**Re: Response to: NOTICE OF DISAPPROVAL  
RAILROAD RACK LAGOON FAN-OUT AREA  
EXCAVATION WORK PLAN  
WESTERN REFINING SOUTHWEST, INC. GALLUP REFINERY  
EPA ID #: NMD000333211  
HWB-GRCC-07-002**

**LIBRARY COPY**  
**RAILROAD RACK OVERFLOW DITCH AND FAN-OUT AREA**  
**SOIL INVESTIGATION WORK PLAN**  
**WESTERN REFINING COMPANY**  
**GALLUP REFINERY**  
**GALLUP, NEW MEXICO**

**FIGURE 3**  
**RAILROAD RACK LAGOON**  
**OVERFLOW DITCH AND FAN-OUT AREA**  
**SOIL SAMPLE LOCATIONS AND RESULTS FOR B-9**  
**WESTERN REFINING, LLC**  
**GALLUP REFINERY**  
**GALLUP, NEW MEXICO**

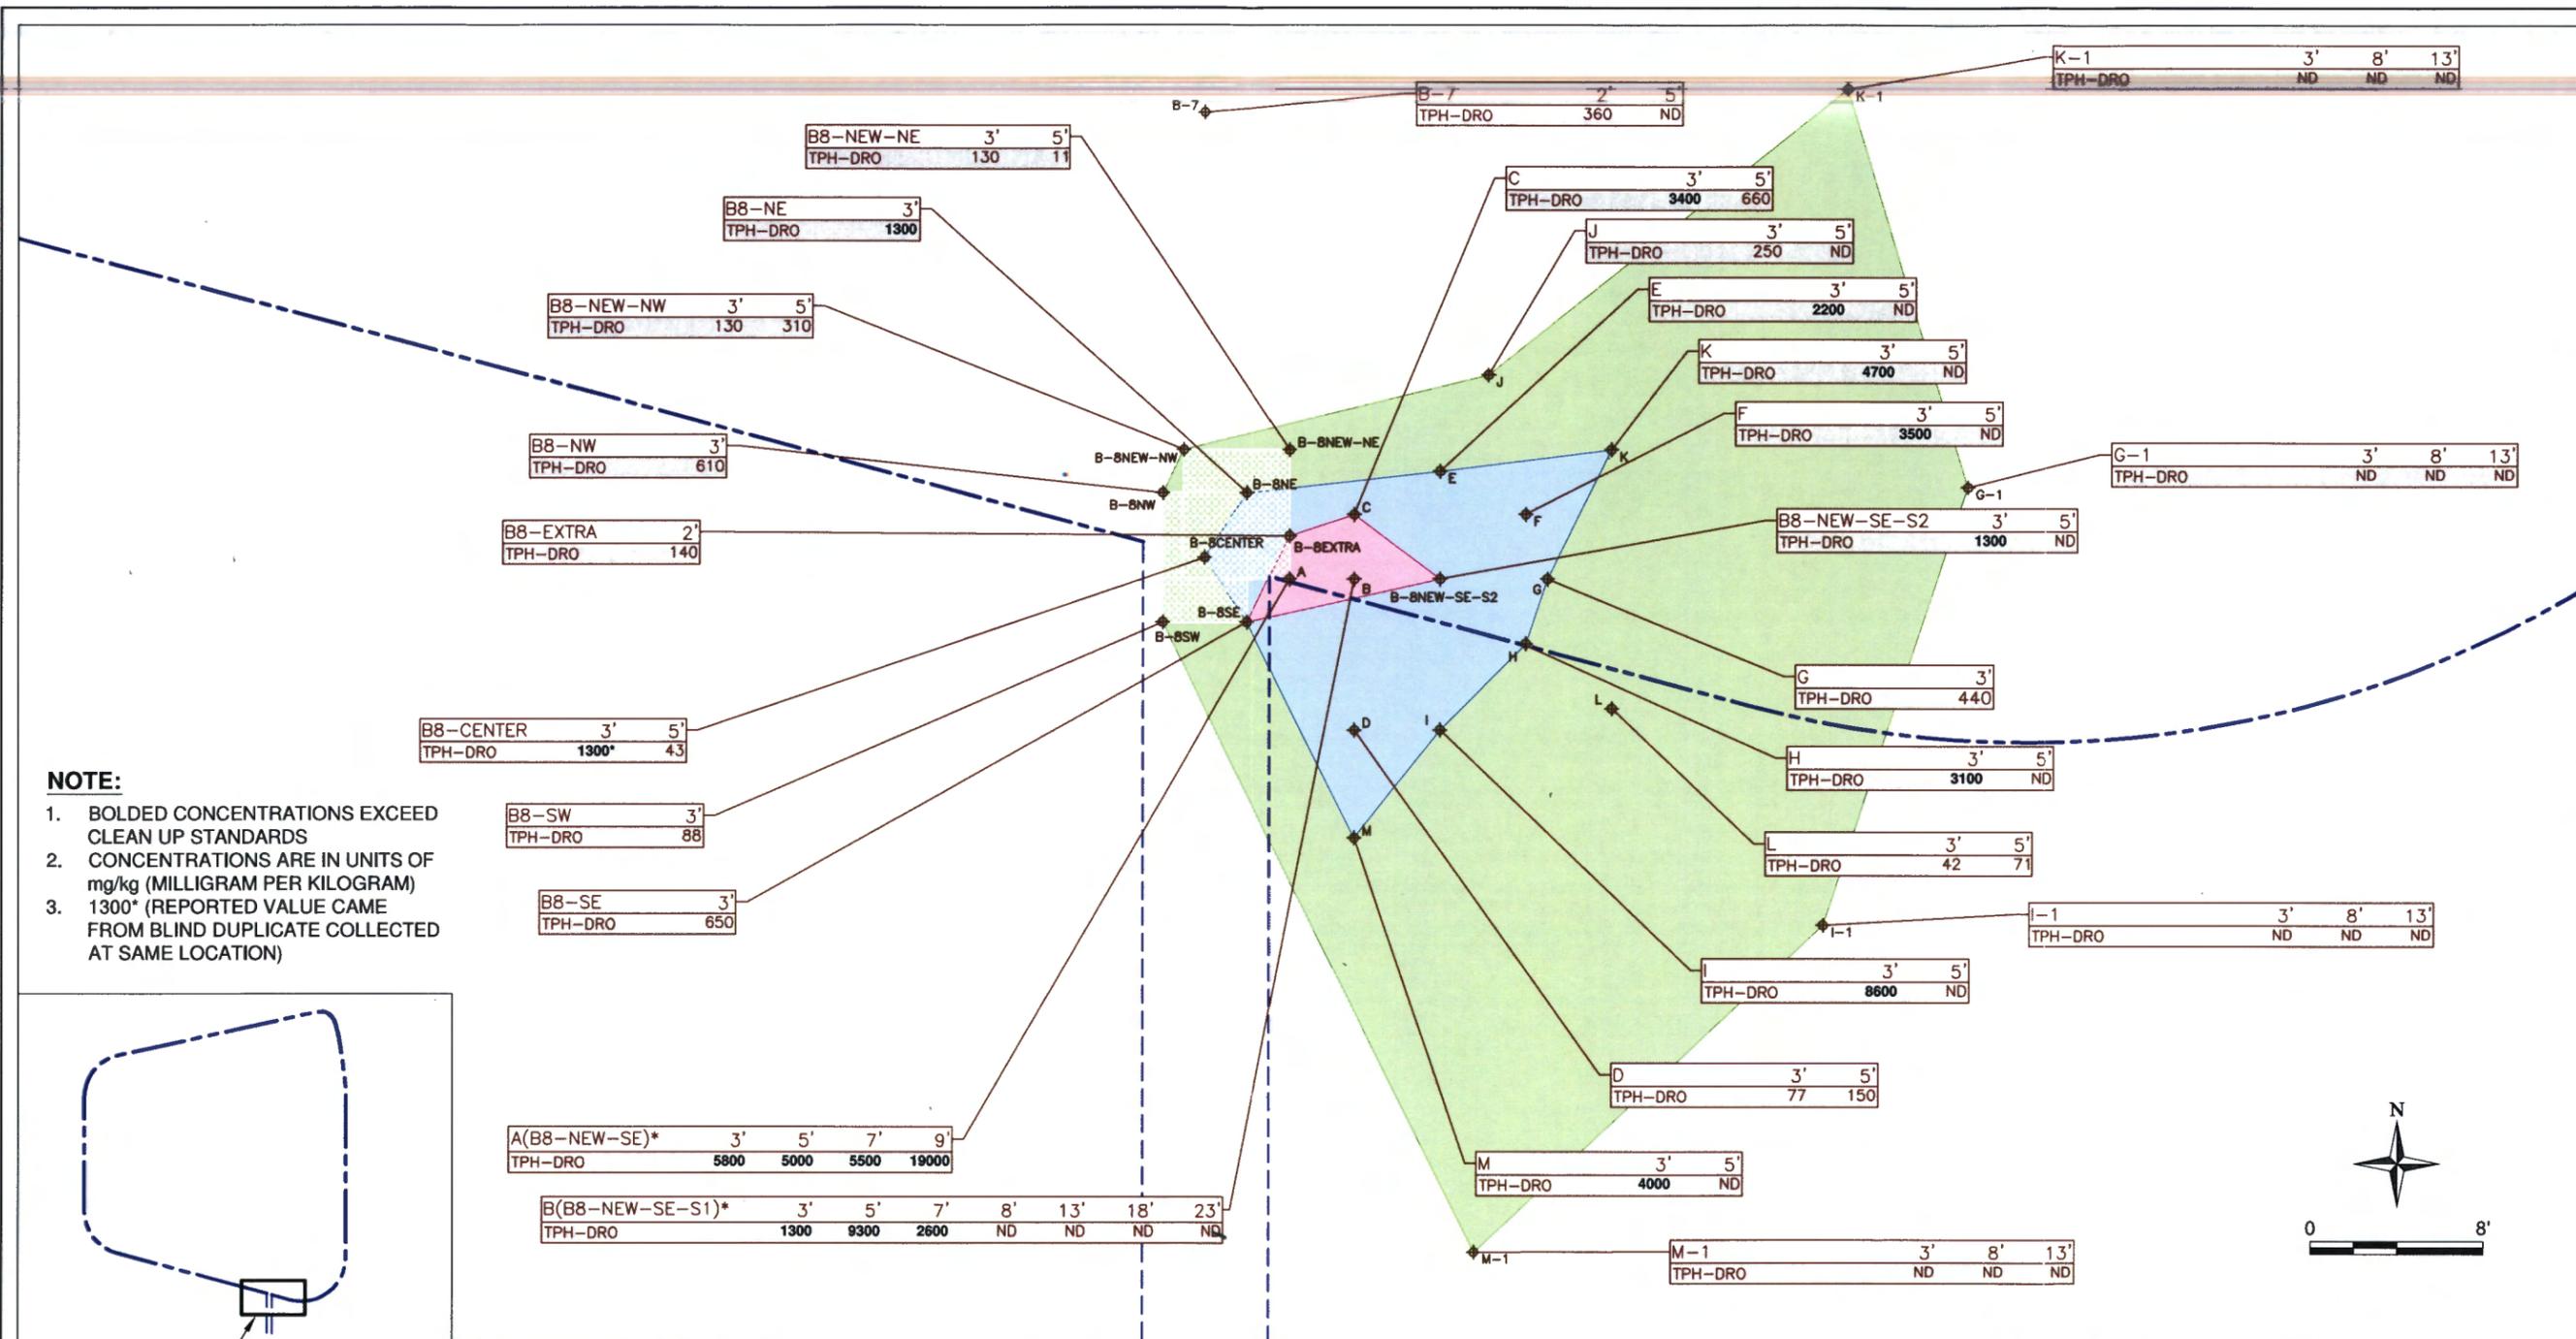
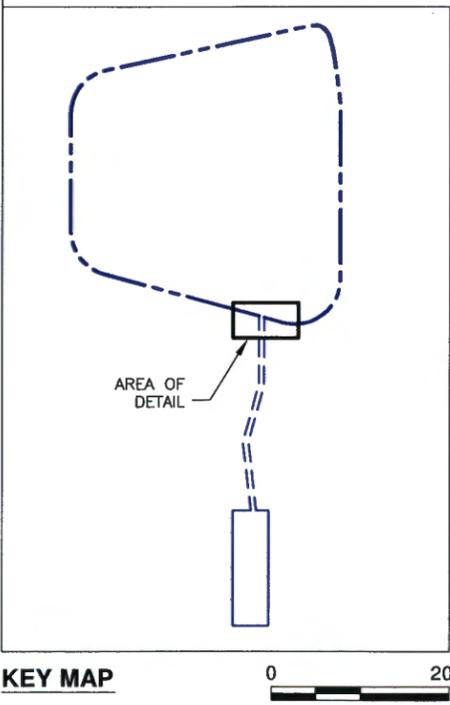
Test pit location B-9 was referenced in the “Completed Field Work” section of the Excavation Plan in an attempt to provide continuity between this Excavation Plan and previous project documents. The B-9 location was discussed in a Project Status Report letter dated October 2, 2007 that was addressed to the Gallup Refinery and also provided to NMED. The purpose of this Excavation Plan is to address contamination in and around the B-8 location, therefore a figure showing the B-9 test pit location and sample results was not originally included. The “Completed Field Work” section of the Excavation Plan has been revised to provide more continuity between the documents. Figure 3 has been provided to show the excavated area and sample results for B-9.

**FIGURE 4**  
**RAILROAD RACK LAGOON**  
**OVERFLOW DITCH AND FAN-OUT AREA SOIL SAMPLE LOCATIONS AND RESULTS AND EXCAVATION AREA**  
**WESTERN REFINING, LLC**  
**GALLUP REFINERY**  
**GALLUP, NEW MEXICO**

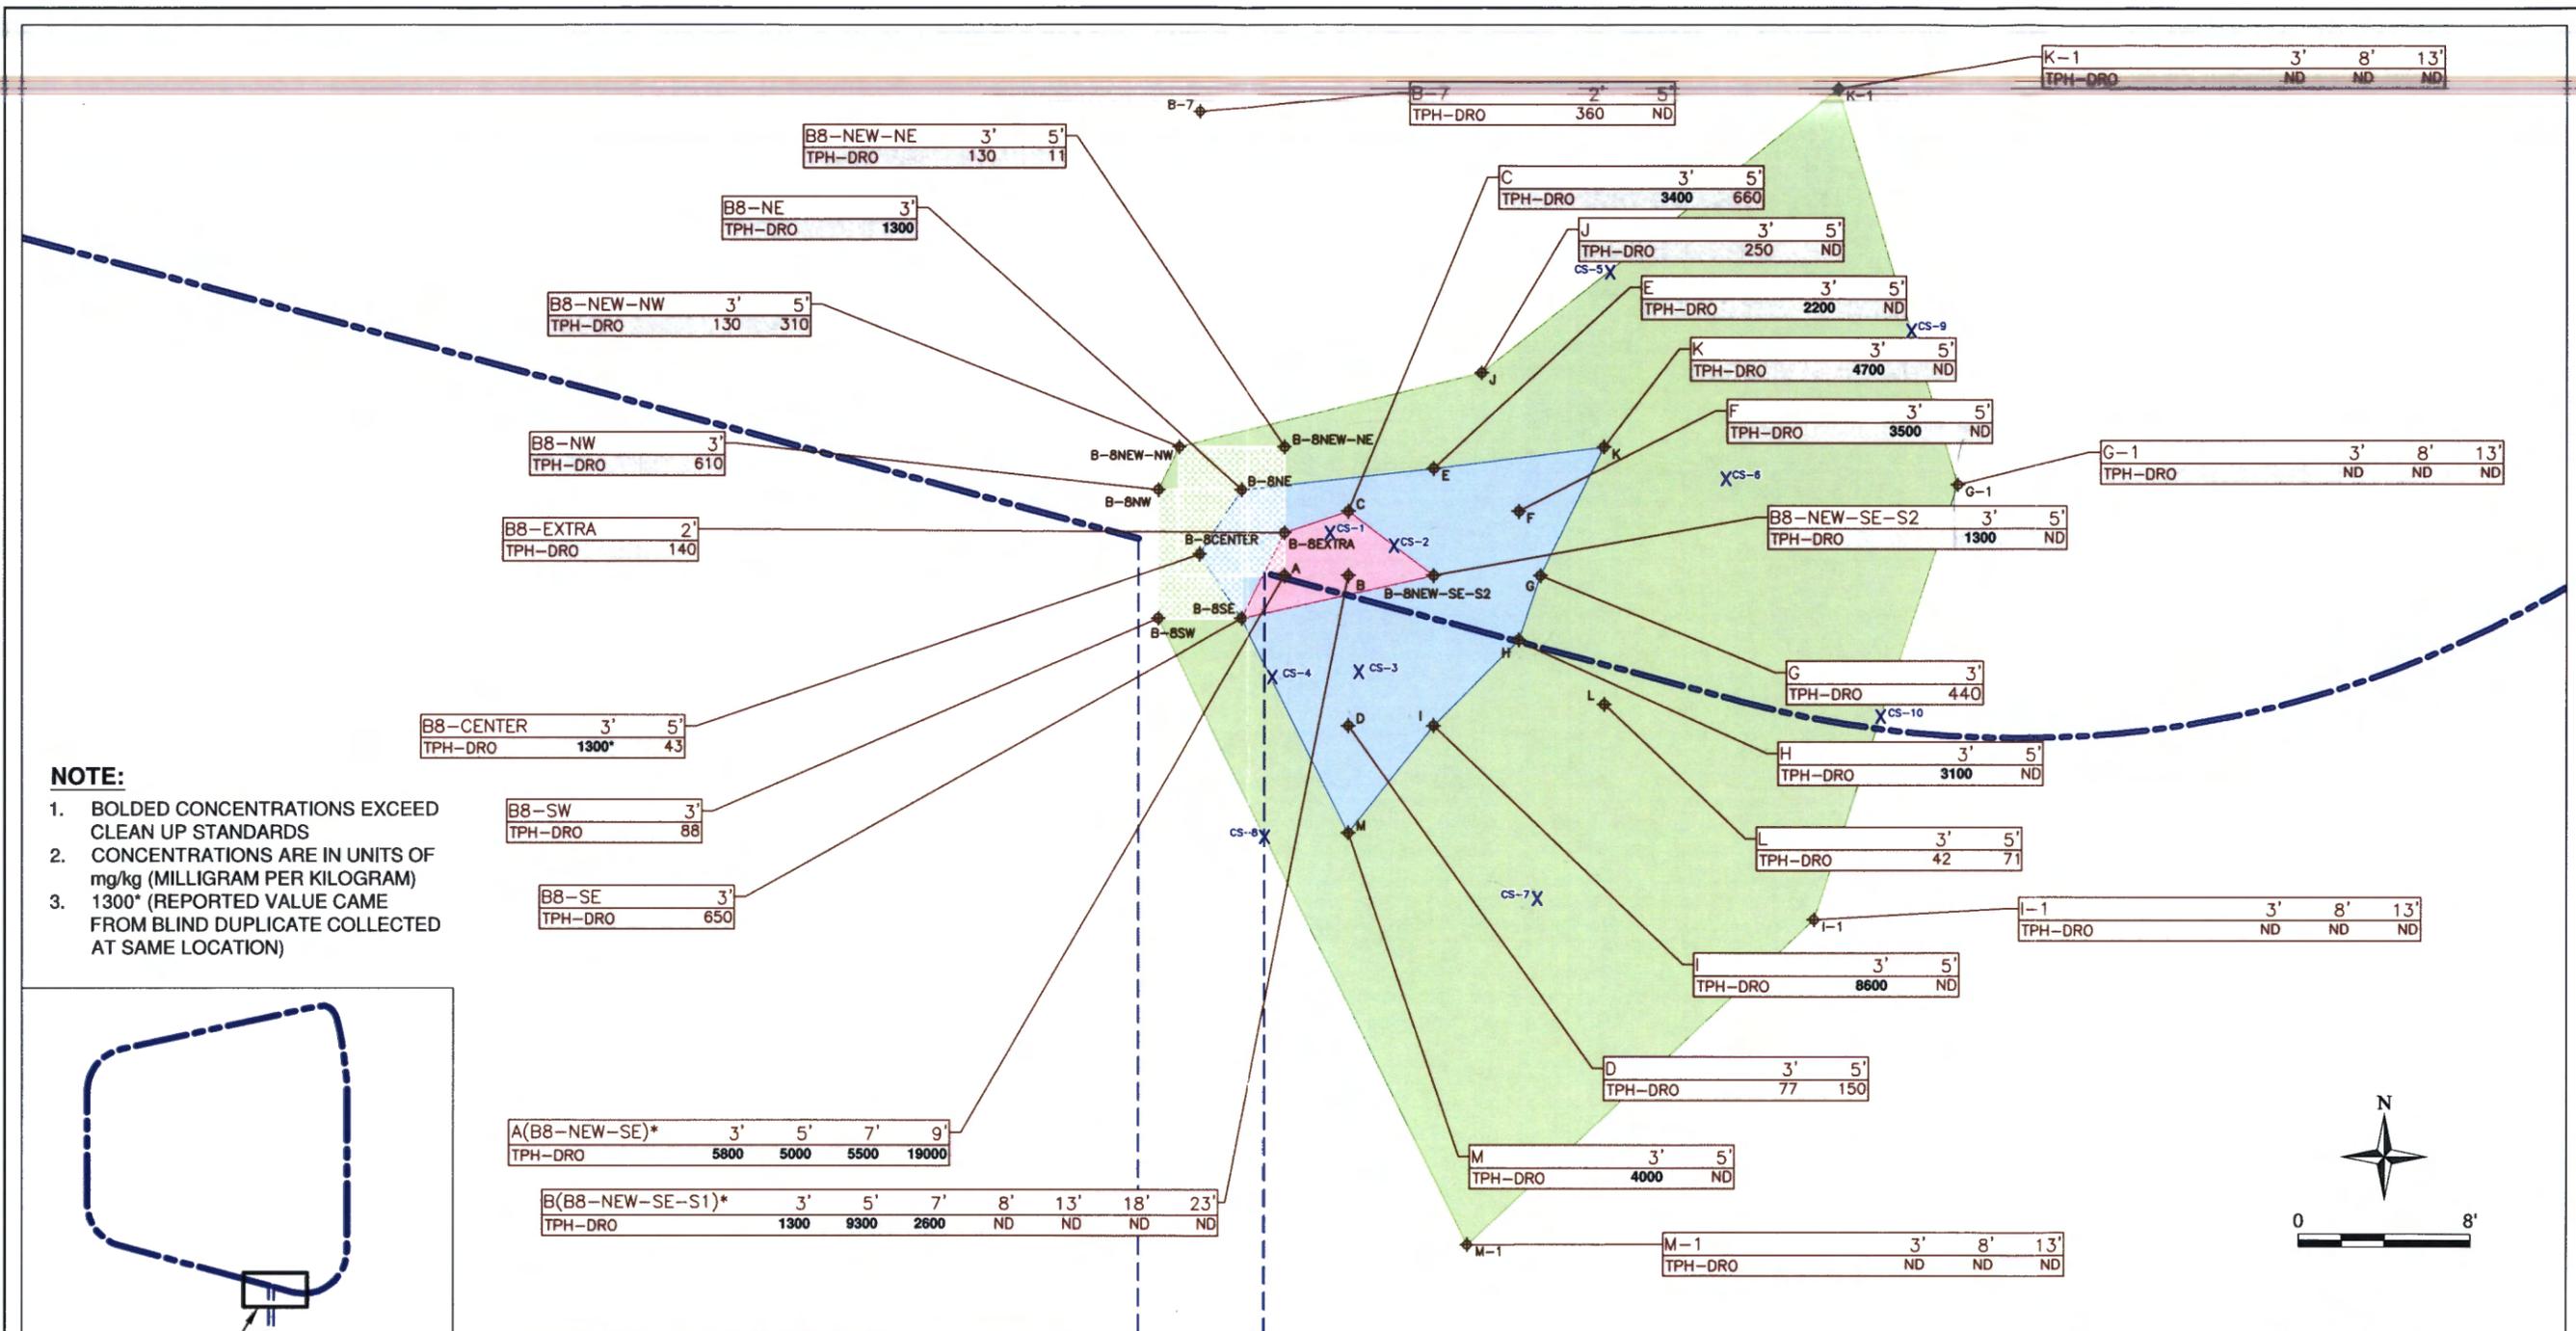
location. Thus, we do not believe revisions to Figure 1 and the Excavation Plan to include “L-1” are needed.

Because this letter serves as a new cover letter to the Excavation Plan, a revised cover letter referencing “I-1” instead of “L-1” is not needed.
